Savannah River Site Watch

March 16, 2023

Comments by Savannah River Site Watch (SRS Watch) on the Draft Environmental Impact Statement for the Surplus Plutonium Disposition Program (SPDP EIS) (DOE/EIS-0549: <https://www.energy.gov/nepa/doeeis-0549-surplus-plutonium-disposition-program>)

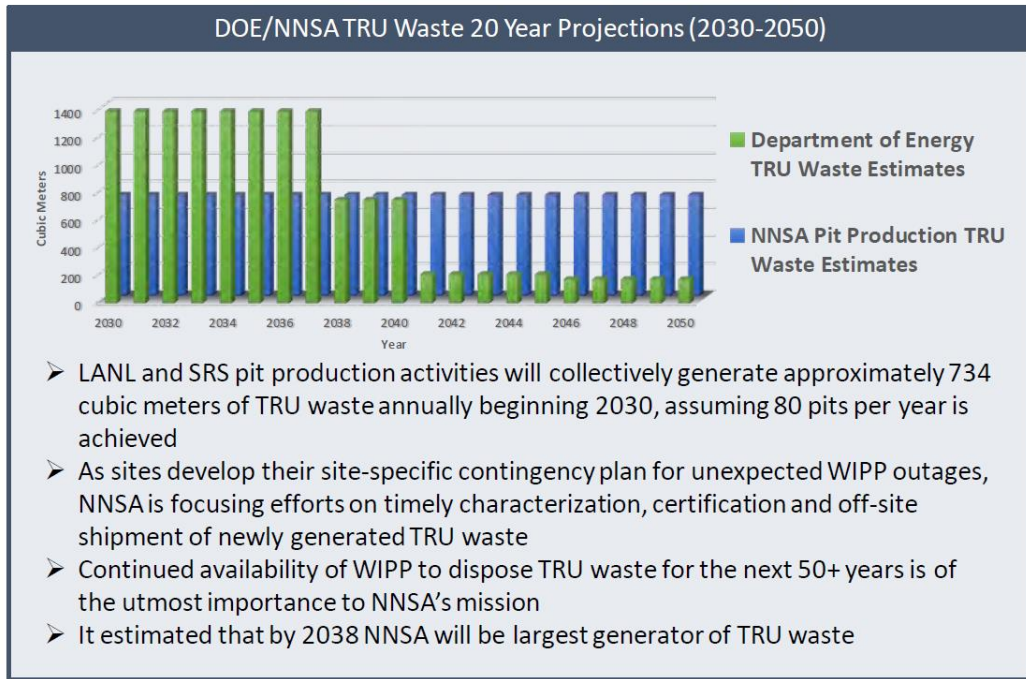
Please provide details of the schedule for downblending plutonium at SRS. Such a schedule should include the amounts of plutonium coming into SRS on an annual basis, how much plutonium scheduled for downblending will be at SRS at any one time and what the schedule is for shipping Criticality Control Overpacks from SRS to WIPP.

The draft EIS says that 113,400 CCO will be packaged over the life of the project (well, the part of the project involving 34 MT of plutonium). How many TRU shipping containers will be needed to move this material? Will disposal of this material receive priority at WIPP or will shipment be dependent on a schedule set by WIPP?
